**BEFORE THE
FEDERAL COMMUNICATIONS COMMISSION
WASHINGTON, D.C. 20554**

In the Matter of)	
)	
Wireless Telecommunications Bureau Seeks)	
Comment on Request for Waiver of Television)	WT Docket No. 06-18
Interference Rules by the State of New York to)	
Implement a 700 MHz Public Safety)	
Communications System)

COMMENTS OF WFUT-TV

In the Matter of)	
)	
Wireless Telecommunications Bureau Seeks)	
Comment on Request for Waiver of Television)	WT Docket No. 06-18
Interference Rules by the State of New York to)	
Implement a 700 MHz Public Safety)	
Communications System)	
To: The Commission

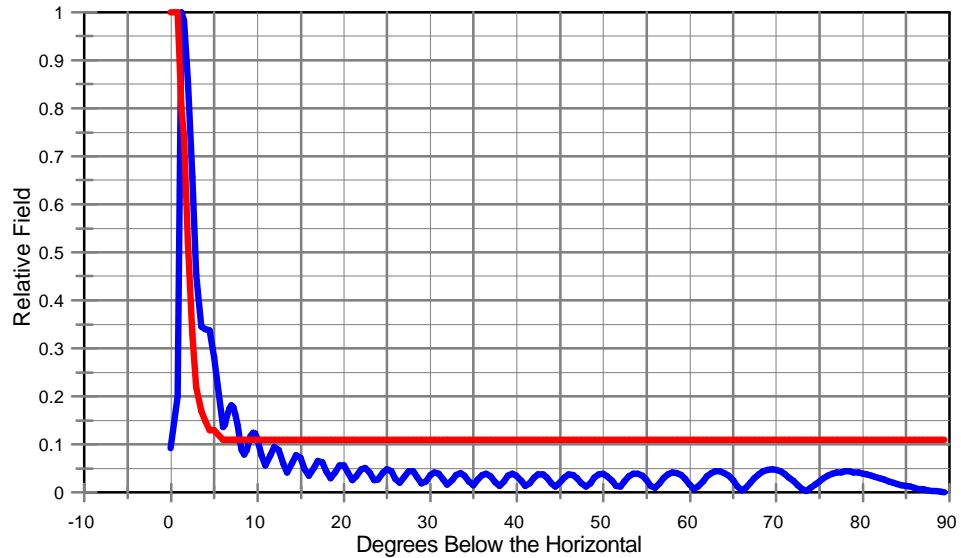
Assumption of the standard vertical plane pattern used in OET-69 would be a slight improvement, but would still be overly-simplistic and would still yield an erroneous result. Table 8 of OET-69 lists the assumed vertical plane radiation patterns which the FCC utilized for transmitting antennas in developing the original DTV table of allotments,¹⁵ and

While the OET-69 assumption is a relative field of 0.11 at all angles more than 10 degrees below the horizontal, the antennas authorized in WFUT-TV construction permit BPCT-20030805AIL and auxiliary permit BXPCT-20031216ADS have much lower relative field values at angles more than 10 degrees below the horizontal than the OET-69 assumption. The WFUT-TV construction permit facility relative field values at those angles range from 0.001 to 0.096, with a median relative field value of 0.034. The operating WFUT-TV auxiliary permit facility relative field values at those angles range from 0.001 to 0.071, with a median relative field value of 0.028.

State's Engineering Study must utilize the actual WFUT-TV vertical plane radiation patterns, as well as the mechanical beam tilt. Otherwise, the result would be a dramatic overstatement of the WFUT-TV signal strength at locations close in to the transmitter site, and a consequent undercounting of the population which would receive interference from the State's proposed mobile radio system. Data on the WFUT-TV antenna vertical plane radiation patterns and beam tilt is available from the Form 301 applications for those facilities, information which is readily accessible in the Commission's CDBS database.

Comparison of Vertical Plane Patterns

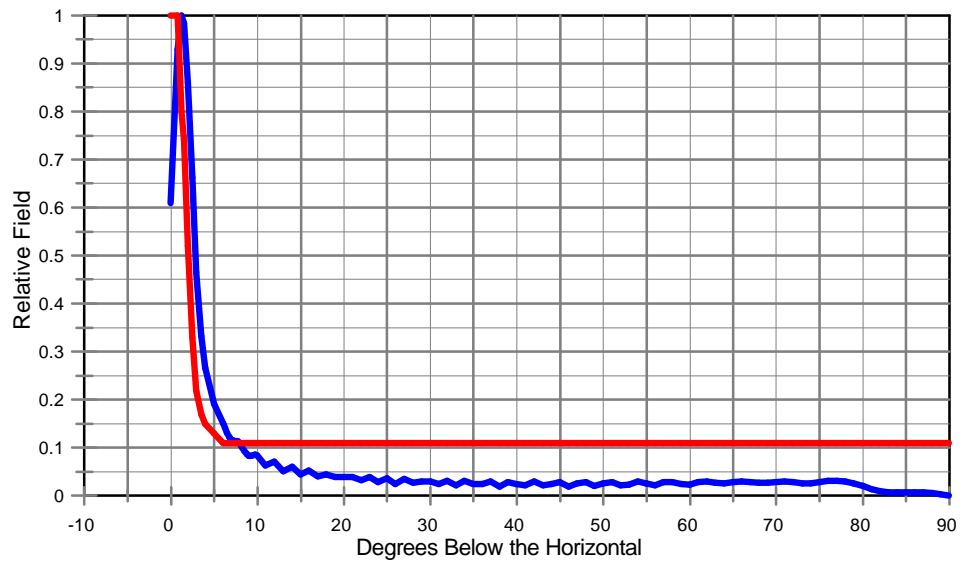
The graphs on the following page compare the actual authorized WFUT-TV vertical plane elevation patterns against the simplistic OET-69 assumption.

Consider a cone extending outward from the WFUT-TV construction permit antenna at 437 meters above ground, with the antenna at the point of the cone and the slope of the cone at 10 degrees below the horizontal. Such a cone would extend a horizontal distance of 2.5 kilometers from the Empire State Building, and encompass a 2000 Census population of over 375,000 persons. The use of the standard OET-69 vertical plane pattern assumption (0.11 relative field at depression angles greater than 10 degrees) overstates the desired signal strength provided to this population by 10 dB when compared with the median relative field value of 0.034 at these angles from the actual antenna. At many depression angles the difference is even more pronounced. Use of the standard OET-69 vertical plane pattern would falsely make it appear that these 375,000 persons were much less susceptible to interference from the State's mobile radio system.

A similar cone extending from the WFUT-TV auxiliary permit antenna at 351 meters above ground would extend a horizontal distance of 2 kilometers from 4 Times Square, and encompass a 2000 Census population of over 224,000 persons. The use of the standard OET-69 vertical plane pattern assumption (0.11 relative field at depression angles greater than 10 degrees) overstates the desired signal strength provided to this population by 12 dB when compared with the median relative field value of 0.028 at these angles from the actual antenna. At many depression angles the difference is even more pronounced. Use of the standard OET-69 vertical plane pattern would falsely make it appear that these 224,000 persons were much less susceptible to interference from the State's mobile radio system.

MAP EXHIBITS

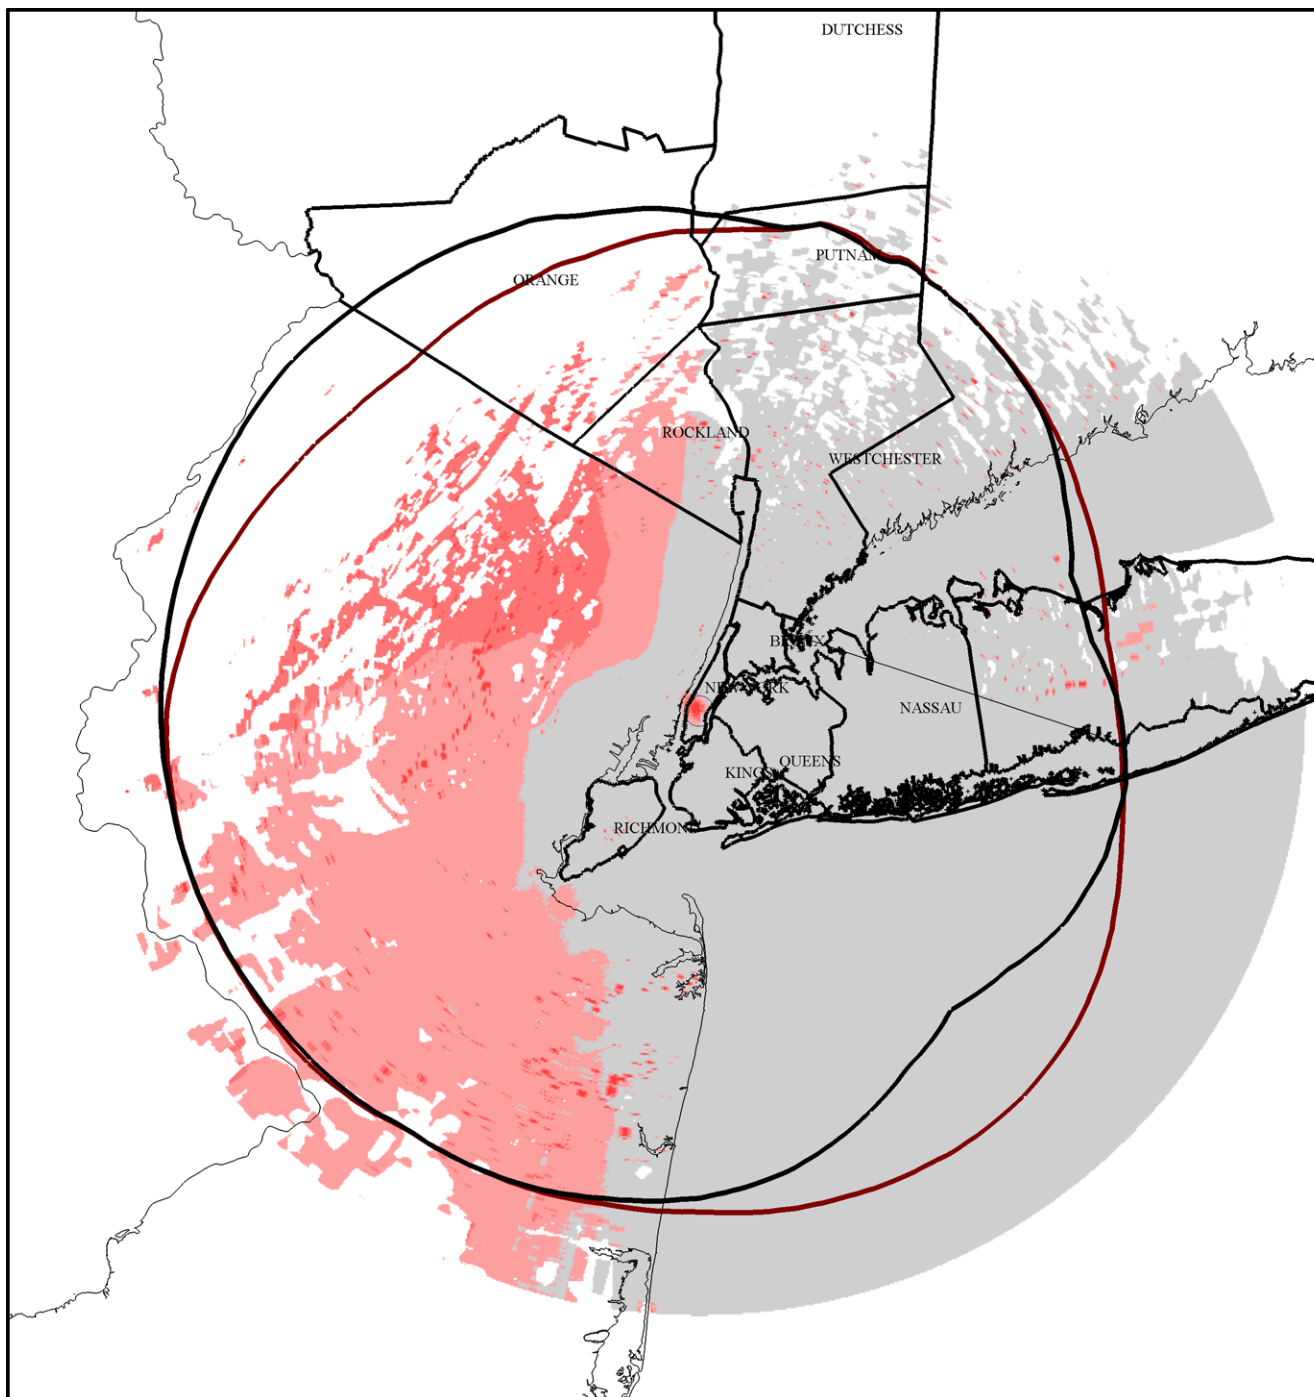
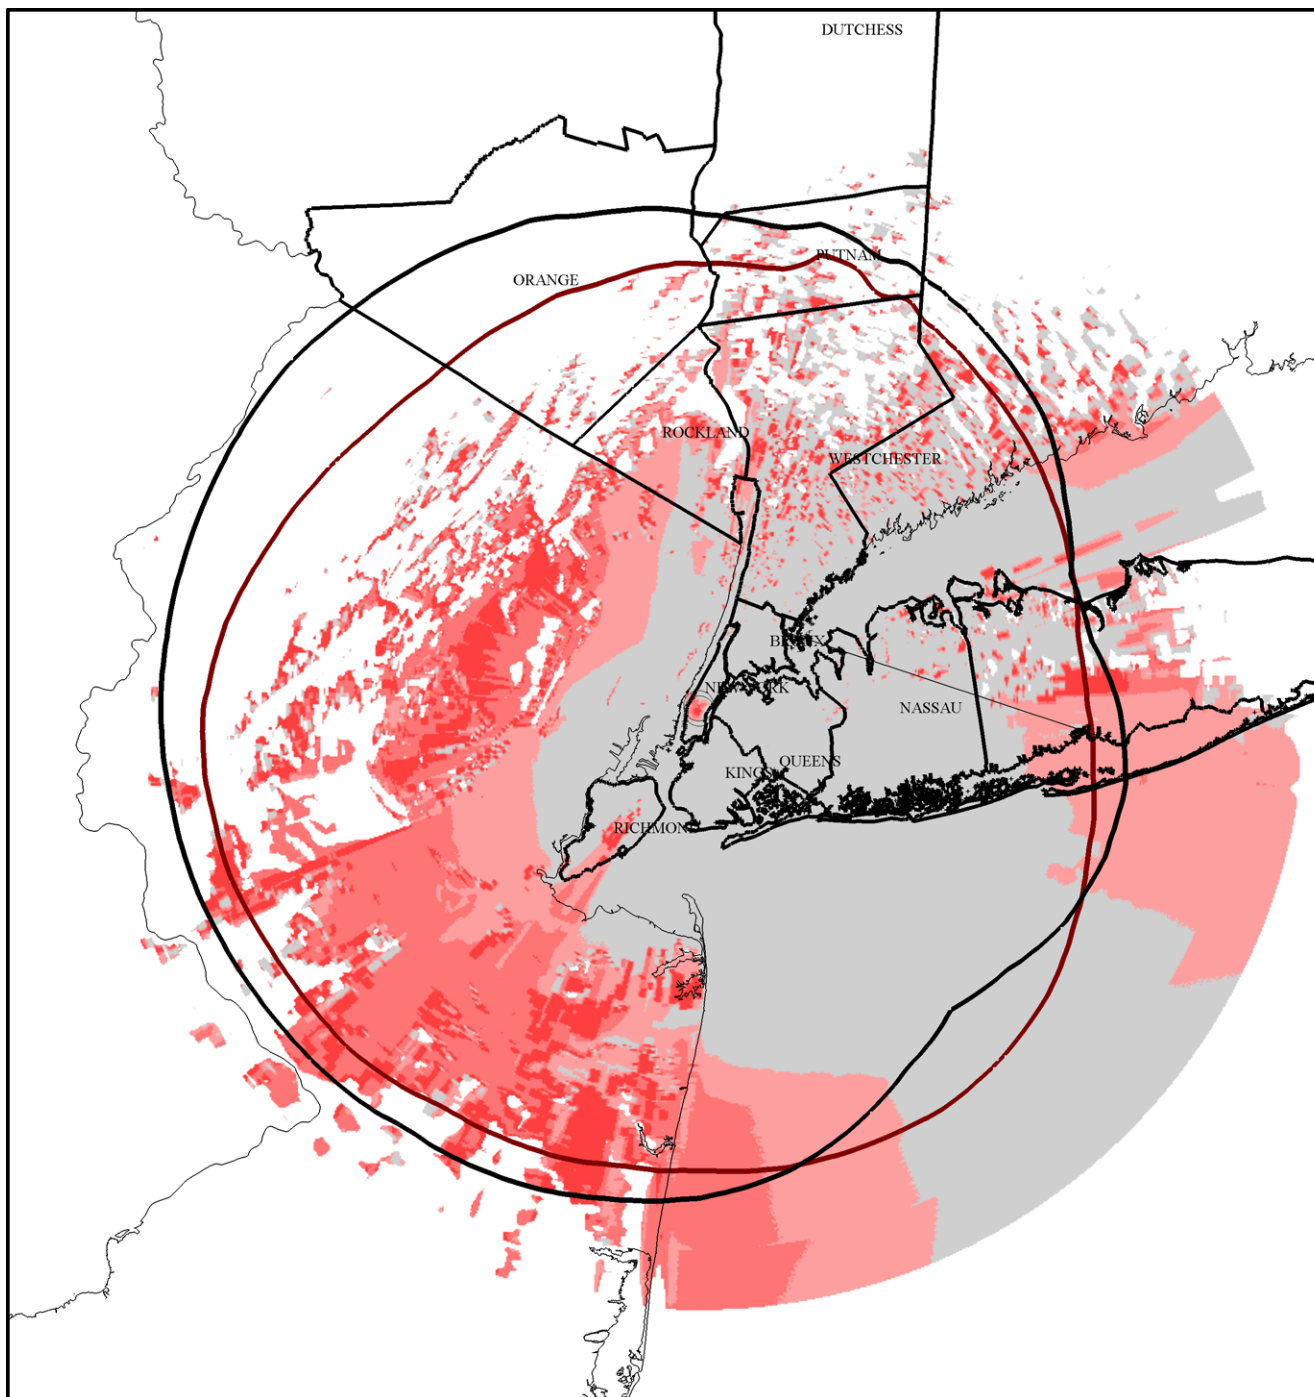
study which compares the predicted Longley-Rice signal strength from the State's assumption of the WFUT-TV licensed facility and OET-69 vertical plane radiation pattern, with the more appropriate assumption of the WFUT-TV main and auxiliary construction permit facilities and the actual vertical plane radiation patterns including mechanical beam tilt.¹⁷

It is easy to see from even a casual review of these map exhibits that erroneous assumptions about the transmitting facility have huge effects upon predicted desired signal strength. Comparing the State's assumption of the WFUT-TV license facility (with OET-69 vertical plane pattern) against the actual WFUT-TV construction permit facility, many areas including the densely populated core of Manhattan Island see a significant decrease in predicted signal strength when the erroneous assumptions are removed from the calculation. Over 3.4 million persons inside the WFUT-TV Grade B contour see a signal strength decrease of at least 1 dB using the WFUT-TV construction permit facility on the Empire State Building. Over 4 million persons inside the Grade B contour see a signal strength decrease of at least 1 dB using the operational WFUT-TV auxiliary construction permit facility at 4 Times Square.
